1.0 APPLICATION DETAILS

- Ref:** 21/06097/FUL
- Location:** 1A Meadow Rise | Coulsdon | CR5 2EH
- Ward:** Coulsdon Town
- Description:** Erection of part two/four-storey building to provide nine (9) self-contained flats (following demolition of existing dwellinghouse and outbuilding), Associated amenity, cycle storage, vehicle parking and waste storage spaces, and Alterations including formation of vehicle crossover and landscaping (following removal of existing crossover).

Image 8.3: 45-Degree Test on plan.

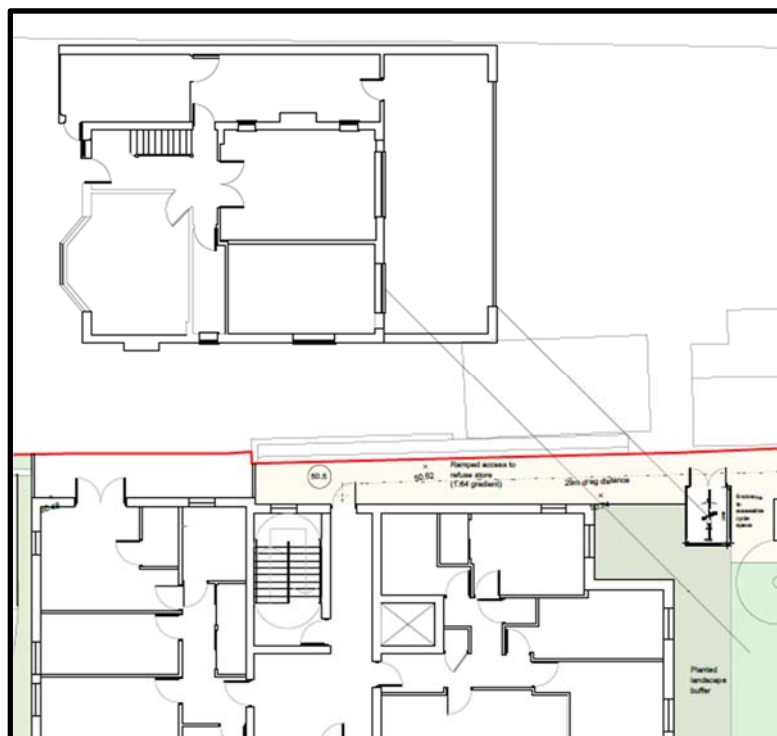
8.22 When a development would result in a building projecting beyond a rear building line, the SDG (2019) states it should follow a 45-degree rule (See: Image 8.3) to avoid any detrimental impacts on adjoining amenity (Paragraph 2.11.1).

8.23 As illustrated on the Proposed Site Plan (dwg. 20.047.101P) listed in the Approved Plans, the areas of the proposed building that would project beyond the rear building lines of the existing neighbouring building at no. 121 Woodcote Grove Road would pass the 45-degree rule test on plan (See: Image 8.4). While the form of the building would be stepped, it would appear neither contrived nor illogical. The stepped ‘L’-shape proposed for the block of flats would allow the development to optimise the housing potential of its corner plot location in a logical evolution to the pattern of development as described in Section 2.14 of Croydon’s SDG.

8.29 As noted previously in this report (Images 8.3 and 8.4), the proposed building would not encroach beyond the 45-degree on plan rule test described and illustrated in the SDG (2019). Additionally, all buildings proposed are sufficiently setback from dwellings on adjoining properties (See: Image 8.5). Therefore, it is noted that the proposed development would not give rise to any undue enclosure or losses of outlook from the neighbouring properties.
